Mamre Road upgrade between the M4 Motorway and Erskine Park Road

Addendum review of environmental
factors
April 2024

This document is an addendum Review of Environmental Factors (Addendum REF) for a proposed modification to the approved 'Mamre Road upgrade between the M4 Motorway and Erskine Park Road' project (the approved project).

Figure 3-1: Proposed property acquisition

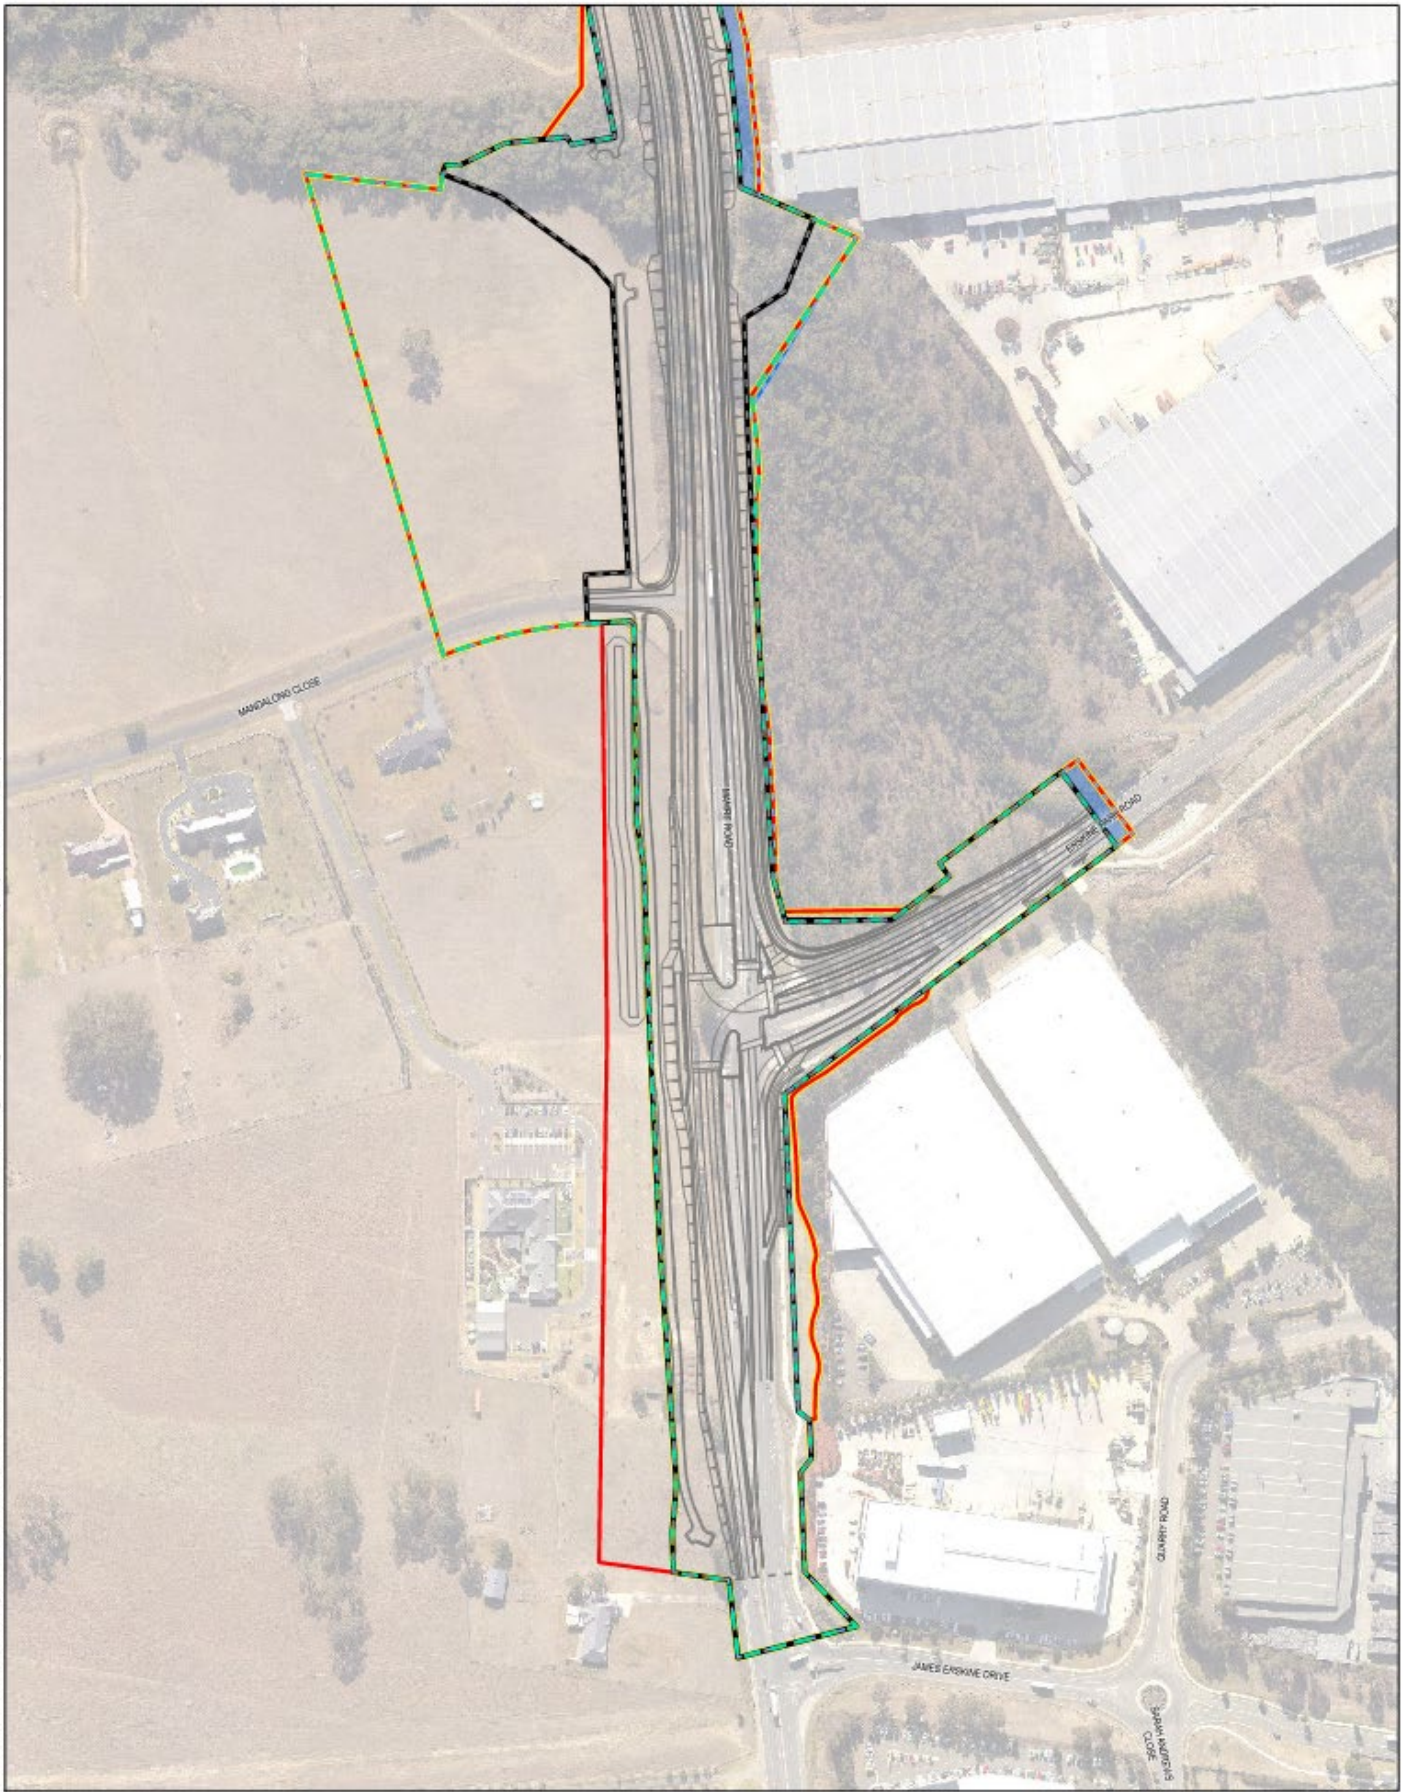
Several major utilities have been identified within the proposal area that would require adjustment and/or relocation. As a result of further consultation with relevant utility providers, the requirements for utility adjustments have been refined and are captured within the proposed modification boundary. The proposed modification would involve additional utility adjustment to those considered in the project REF. This includes a water main which would require excavation along Walker Lane beyond the approved proposal area, which would result in an extension to the boundary.

Figure 1: Basin filling works and revised REF boundary

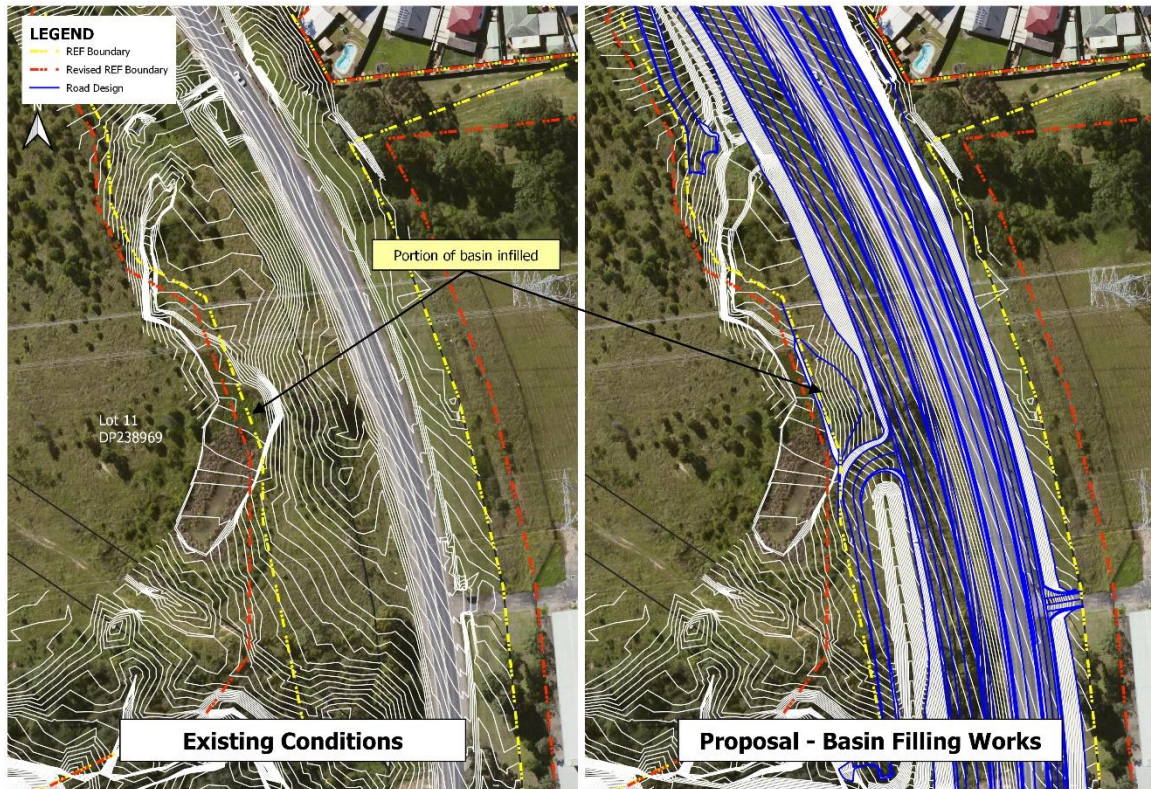
The proposed basin filling works is incorporated in Detailed Design for the IFT design stage. Flood modelling has been carried out as part of the IFT stage with inclusion of the basin filling works. Outcomes of flood modelling for the revised REF boundary with basin filling works will be based on the IFT design.

Figure 2: 1% AEP local flood level impacts

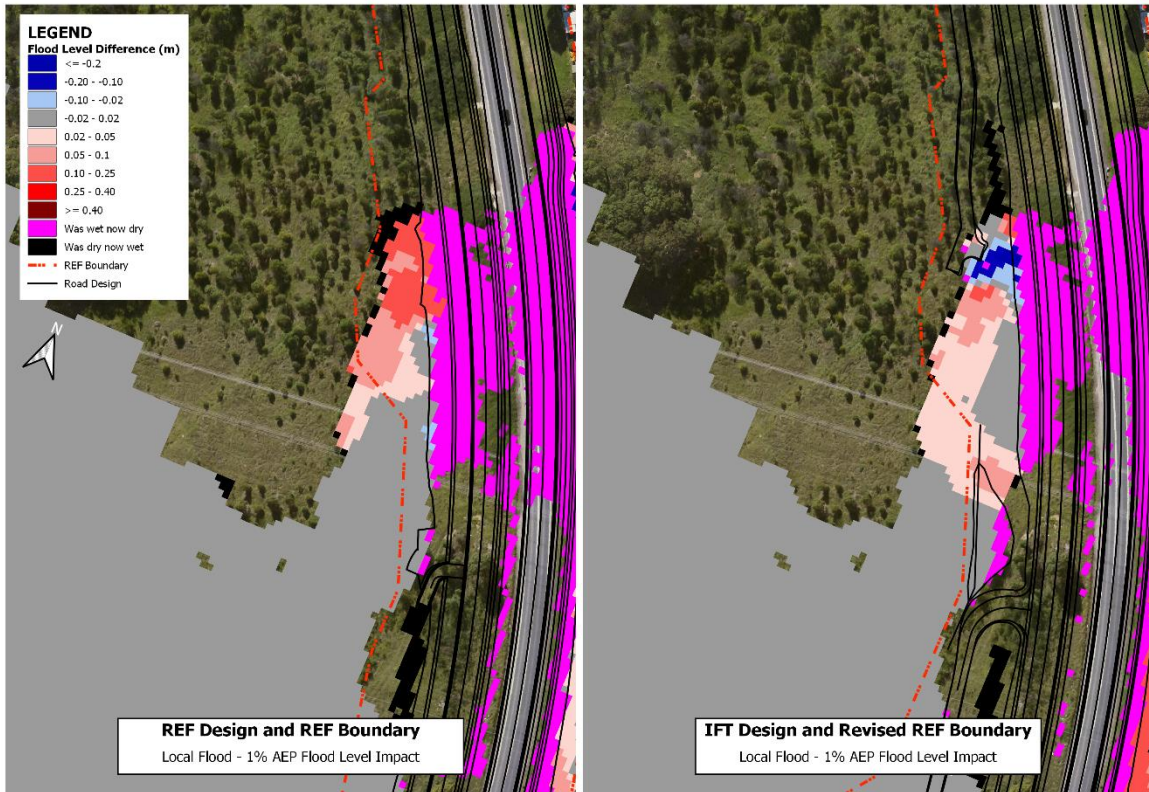
As a result of storage loss by partially filling the existing basin, there are minor changes in extent of flood level increases from existing in the 0.02 m to 0.05 m range for the 1% AEP flood. This minor increase in flood extent is localised within 6 m of the existing inlet stream of this existing basin. Figure 2 shows 1% AEP local flood level impacts for the REF and IFT design.

Figure 3: 5% AEP local flood level impacts

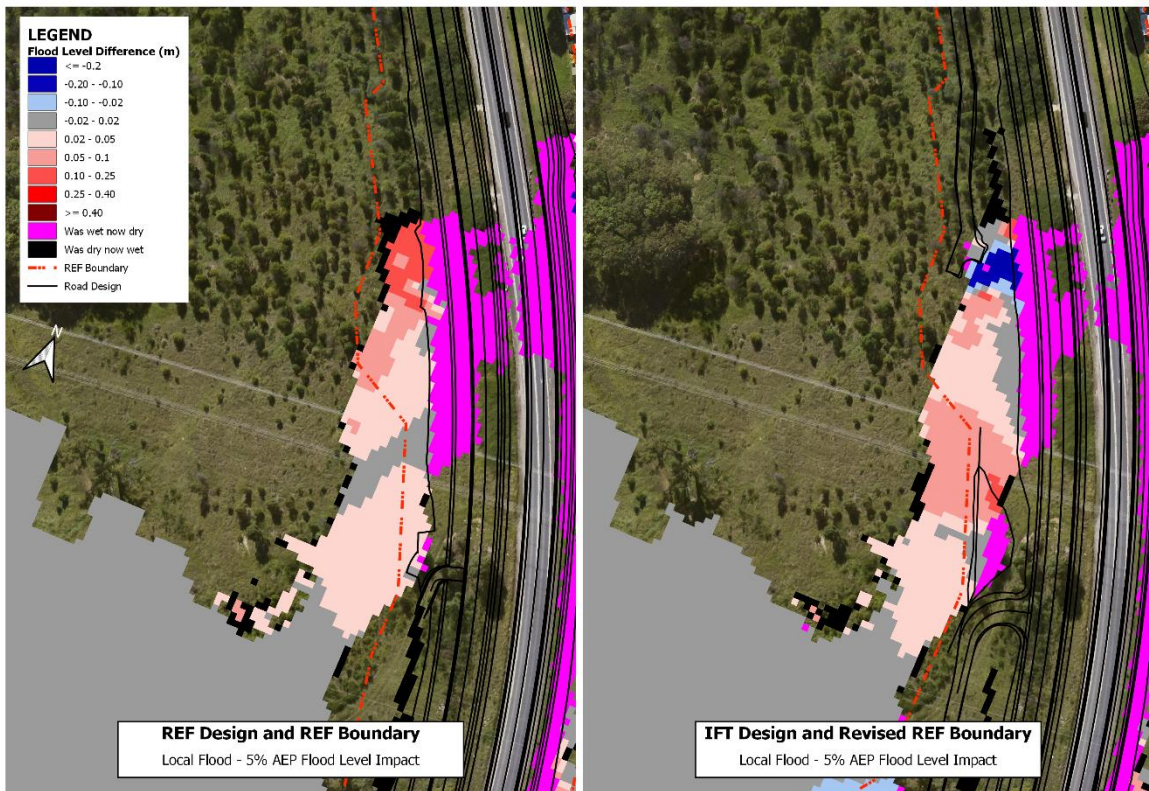
More frequent floods such as the 10% and 2% AEP events experience similar extents as the 1% AEP flood impacts. The 5% AEP flood event experiences a greater flood extent of flood level increases from existing between 0.02 m to 0.05 m from both the REF design and IFT design. As a result of basin filling works from the IFT design, there is a consistent extent of adverse impacts, however a minor increase in impacts in the 0.05 m to 0.10 m range in the 5% AEP flood. Figure 3 shows 5% AEP local flood level impacts for the REF and IFT design.

Figure 5: 1% AEP local flood velocity impact mapping

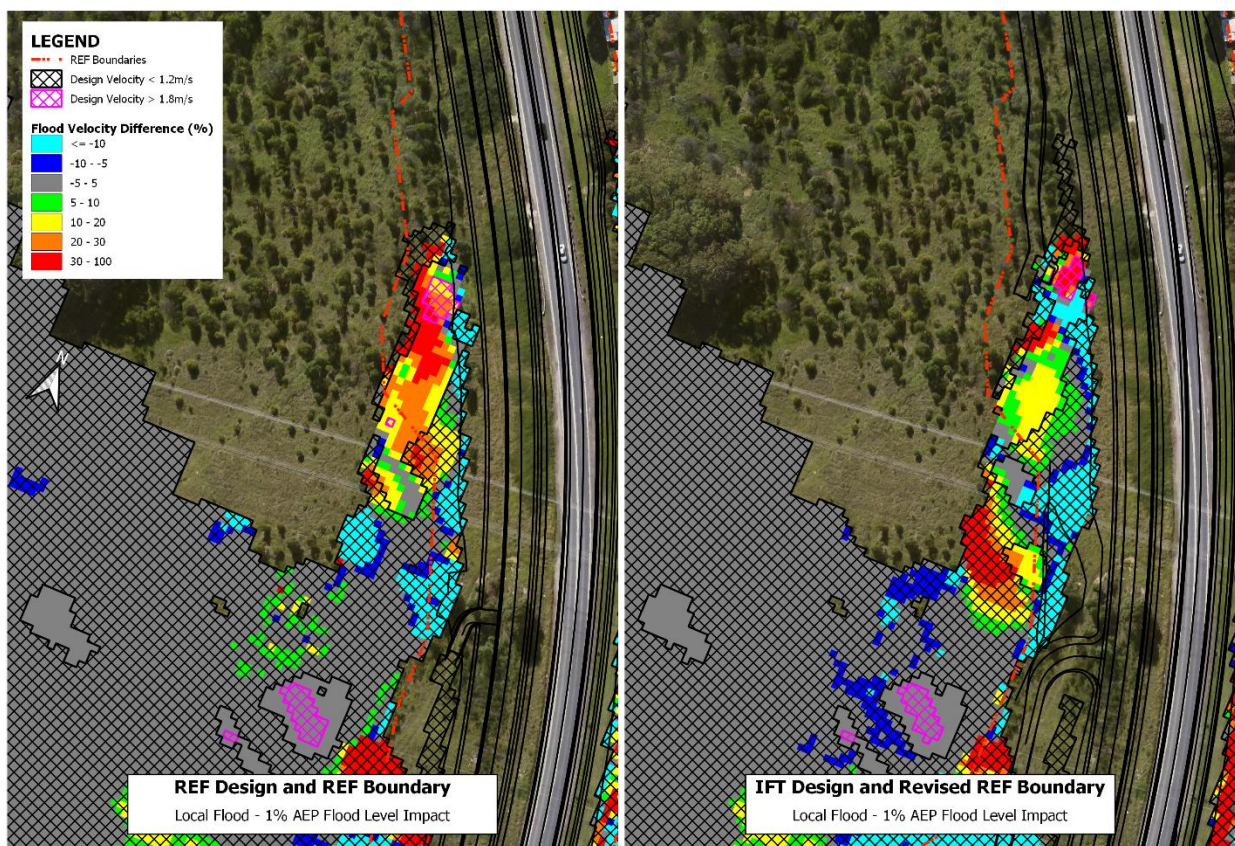
Flood velocity impact mapping of both the REF and Revised REF designs for the 1% AEP local overland flood are presented in Figure 5. Regions where land is prone to local overland flooding for

Maximum flood velocities along the embankment of basin filling works are no more than 1.25 m/s. As this is less than the 1.8 m/s erodibility threshold, there is a low risk to erosion to embankments from basin filling works.

The effect of basin filling works in the Revised REF produces negligible impact to the risk of erosion to the flood plain and to design embankments for the local overland flood.

Figure 6: 1% AEP mainstream flood velocity impact mapping

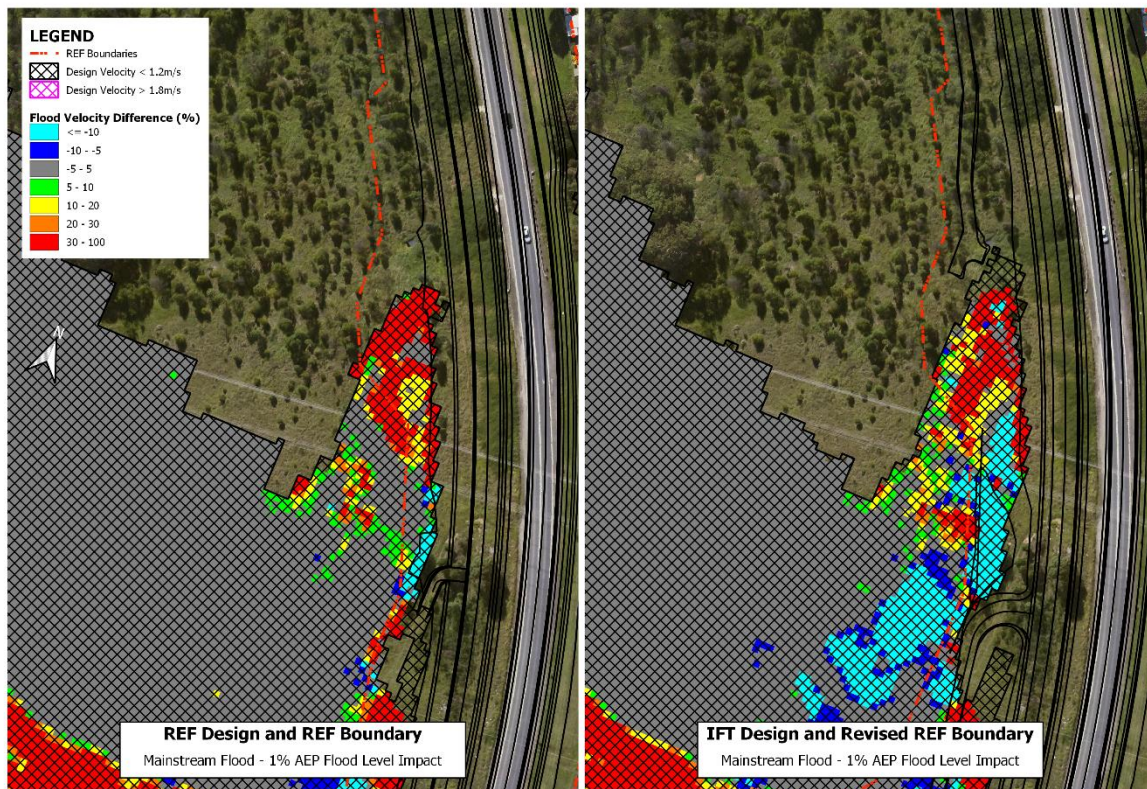
Flood velocity impact mapping of both the REF and Revised REF designs for the 1% AEP mainstream regional South Creek flood are presented in Figure 6. Regions where land is erosion resistant to regional flooding for design velocities less than 1.2 m/s are hatched in black. Both the REF and Revised REF designs generate no adverse impact on the risk to erosion as all regions experiencing a change in velocity are below the regional flood erodibility threshold.

The maximum flood velocities in the vicinity of the floodplain and along the embankment of the basin filling works are no more than 0.45 m/s. As this is less than the 1.2 m/s erodibility threshold, there is a low risk to erosion to embankments of basin filling works.

The effect of basin filling works in the Revised REF provides negligible impact to the risk of erosion to the flood plain and to design embankments for the mainstream regional South Creek flood.
